To: ARCF_SEIS@usace.army.mil
Cc: PublicCommentARCF16@water.ca.gov
Subject: Comments Regarding American River Common Features (ARCF) 2016 Draft Supplemental Environmental Impact Statement/Subsequent Environmental Impact Report (SEIS/SEIR) – December 2023 Report and Appendices; Specific Comments Pertaining to Hydrology, Erosion, etc.
9 February 2024

The extensive comments detailed below focus on the Lower American River projects of the draft SEIS/SEIR, particularly Contracts 3B, 4A and 4B, and were generated and vetted, after careful review of all available documents, by a team of qualified active and retired civil engineers, an emeritus CSUS professor, PhD in Biological Sciences, and a UCD PhD candidate in the history of Sacramento Valley flood control. The comments herein were further vetted by an attorney.

Figure 10-1: ARN Reach A U9 LM 1.32 Without Project Analyses Results

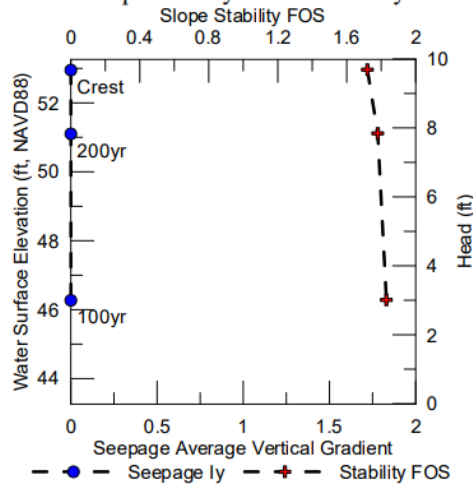
- e. Geotechnical Report, 2016 GRR, Figure 10-1, Appendices Page 705
 - i. "As no seepage and stability deficiencies exist, no further improvements are recommended."

FIGURE 7 Cross-sections were compared along three locations of the American River (a). At Section 1-1, the vegetation model significantly damped out flows along both banks (blue regions) and increased velocities in the centre of the channel (red region) compared to LES without trees (b).

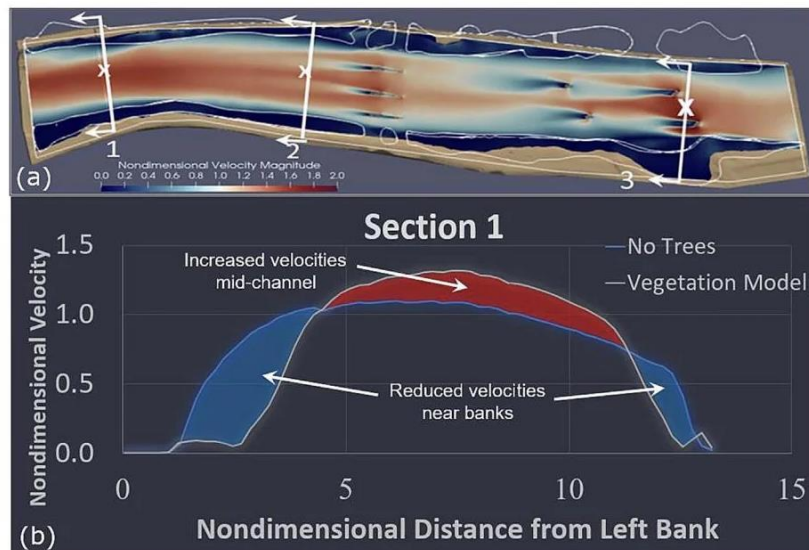
9. Modern advanced modeling also shows that trees protect banks by redirecting the energy of a river towards the center of its channel. Removing these trees may exacerbate erosion and make us less safe. Because of large trees, the water along the river banks in this part of the river during a storm is stagnant. It does not move fast enough to scour the banks. Kevin Flora and Ali Khosronejad found that at the cross-sections of three locations of the American River, trees significantly reduce velocity flow

along both banks, while increasing velocities in the center of the channel. (A) Empirically, this is confirmed by a photo showing a dog wading in the waters (see picture) along the riverbank in front of Larchmont Park during the 80,000 cfs high water mark in 2017. This empirical evidence is further confirmed by velocity contour maps provided by the Sacramento Area Flood Control Agency in a report prepared by MBK Engineers called "The 2017 Lower American River Stream Bank Erosion Report." These velocity contour maps show that during 145,000 cfs flows, the velocity along the banks between River mile 10.5 and 11, an area that encompasses the proposed project footprint in front of Larchmont Community Park, is only expected to be 0-2 feet per second, well below any velocity that could scour the banks. (B) However, if USACE removes large trees to install launchable features, water will move along the banks much faster.

Figure 17-1: Combined Probability of Poor Performance for Without Project Conditions

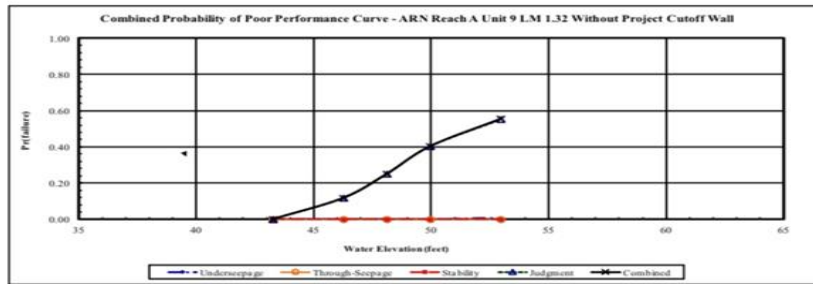
2. Section 17.0, Probabilistic Analyses, provides a “probabilistic evaluation” of each index point to evaluate uncertainty in model parameters regarding seepage and slope stability. This section provides graphs of probable levee performance without the project and with the project. Figures 17-1 and 17-2 supposedly show the improvement of performance of the levee at Howe Avenue. However, Figure 17-1 shows the curve without the project also does not include the cutoff wall, whereas Figure 17-2 curve includes the cutoff wall. This is therefore an “apples to oranges” comparison of the need for erosion protection.

3. Section 17.0 portends to apply a “probabilistic analysis” and provides graphs to show the increase in performance of the levees, as if this can be quantified with mathematical precision. However, the analysis itself includes a judgement factor (Geotechnical Report, page 31 of 48): “A judgment based conditional probability function for each analyzed cross-section was based on existing conditions of the levee such as encroachments on the levee slopes, vegetation on the levee slopes and in the vicinity of the levee toes, existing cracks and holes due to animal burrows, erosion of the waterside levee slopes and riverbank, and considering the past history of sand boils or slope failures. Generally, past experience with poor performance at utility crossing and rodent activity indicates the risk of failure is somewhat significant in the analyzed areas.” Therefore, the graphs themselves are misrepresentative; engineering judgement and observations are important, but they cannot be quantified and should not be presented as such.

Figure 10-1: ARN Reach A U9 LM 1.32 Without Project Analyses Results

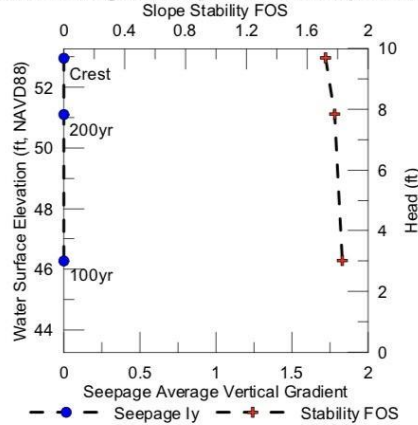
1. Geotechnical Report, 2016 GRR, Figure 10-1, Appendices page 705, in the text above Figure 10-1, reads: "As no seepage and stability deficiencies exist, no further improvements are recommended." Therefore, the Geotechnical Report refutes the need for erosion protection at Howe Avenue to prevent seepage.
